From: [Stephen Ubl](#)
To: [Marcia Moermond](#)
Cc: [Nathan Bruhn](#)
Subject: FW: 733 Fairview Ave. N.
Date: Monday, March 11, 2024 1:04:54 PM
Attachments: [image005.png](#)
[image006.png](#)
[image007.png](#)
[image008.png](#)
[image009.png](#)
[image010.png](#)

I have been told that you are engaged in a project at 733 Fairview Ave. N., a building identified as a Vacant Building Category III. If you have questions regarding Plan Review, Permitting, Inspections, or Appeals, please reach out to me and I can see what I can do to move this project along.

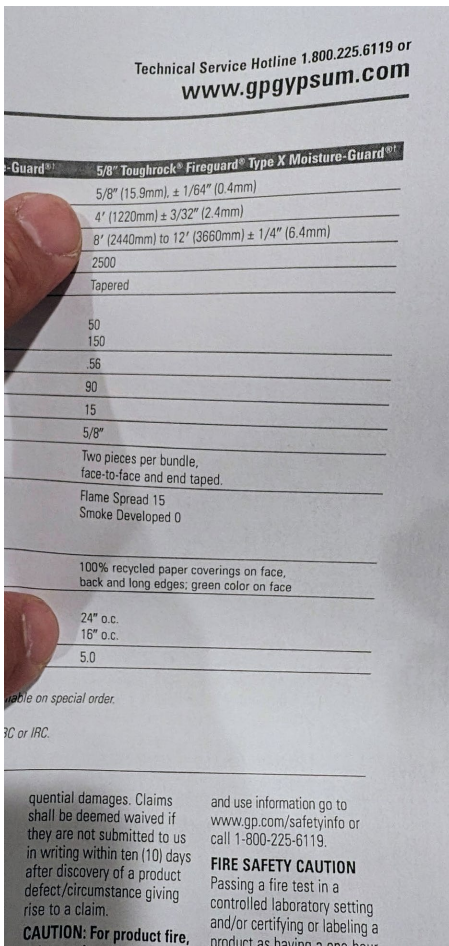
To this end, as illustrated in the Georgia-Pacific manufacturer's installation recommendation instructions for the 5/8" Toughrock Fireguard ("green" board) Type X Moisture Guard gypsum sheetrock that has been installed in the 733 basement ceilings, Framing Spacing, Maximum for Ceilings is **16" o.c., not 12" o.c.**

To this end, the basement 5/8" ceilings at the 733 Fairview Ave. N. property remain in compliance with both the CertainTeed ("purple" board) and the Georgia-Pacific ("green" board) manufacturer's installation recommendations of a minimum of 16" o.c.

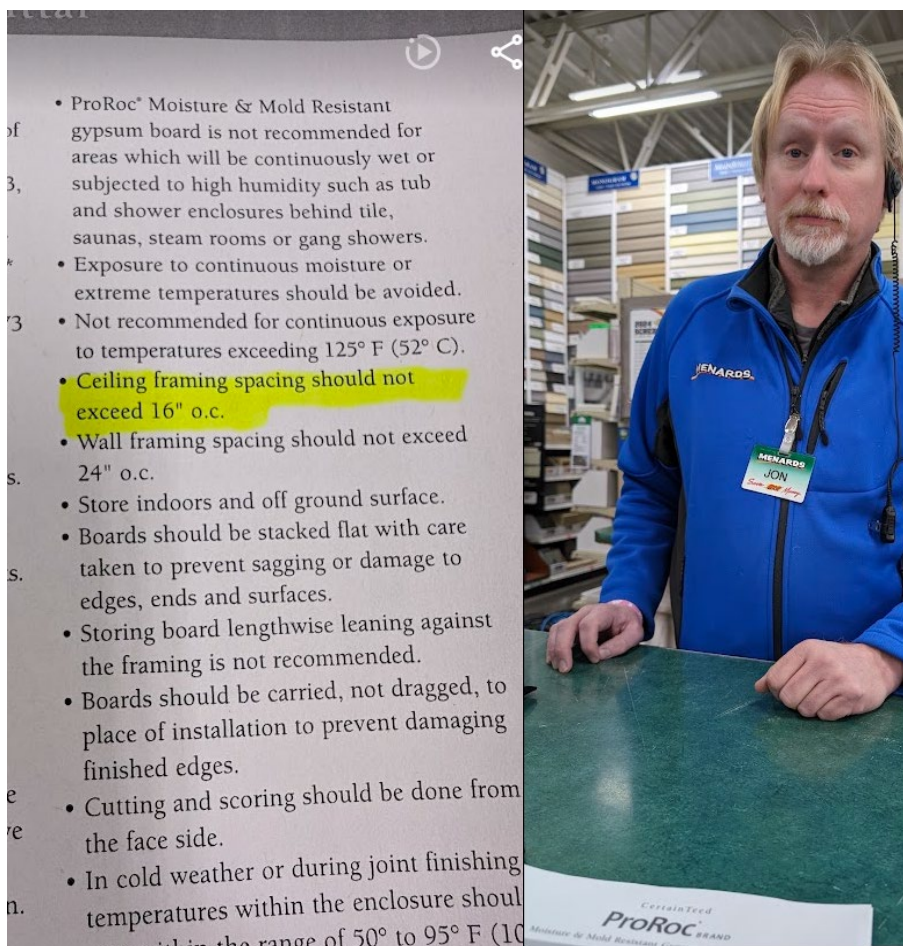
Tuesday, after our meeting, I went to Menards. I eventually was able to speak with Jon, in the building center, who is familiar with my situation. I asked him to provide me with the literature on the manufacturer's installation instructions for the moisture-mold-resistant sheetrock to determine whether what I did in my home complied with the manufacturer's installation recommendations. I asked him specifically whether the moisture & mold resistance gypsum board he sold me from Menards to install on many of the walls and ceilings, per the manufacturer's instructions, called for it to be installed on 16" on center or whether it required a lesser distance. Without saying a word, Jon got on his screen, printed, and with his yellow highlighter, marked the following and slid the paper over to me: **"Ceiling framing spacing**

should not exceed 16" o.c." Based on the above, I complied with the manufacturer's gypsum board moisture-mold-resistant installation recommendations, Stephen.
